REQUEST FOR INFORMATION **DATE:** December 01, 2016 **NO.:** RFI-366

Project Name: 15051-Webster University Interdisciplinary Science Building

Subject: Electrical boxes shown in J1 type wall

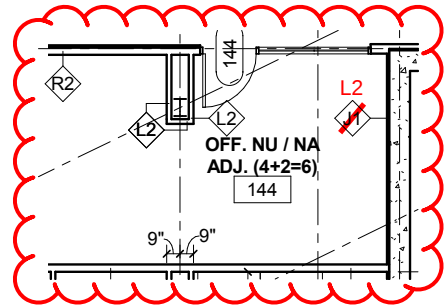
E0101.B and T0101.B show boxes placed along the east wall of room 144. A0101.B calls for a J1 partition along this wall which consists of 7/8" hat channel. This wall would need to be at least 3 5/8" studes to install the boxes as shown.

Suggestion: Please advise if wall is to be furred out.

**CHANGE 'J1' PARTITION TO PARTITION TYPE 'L2'
(SIMILAR TO ROOM 154) TO ACCOMMODATE BOXES.**
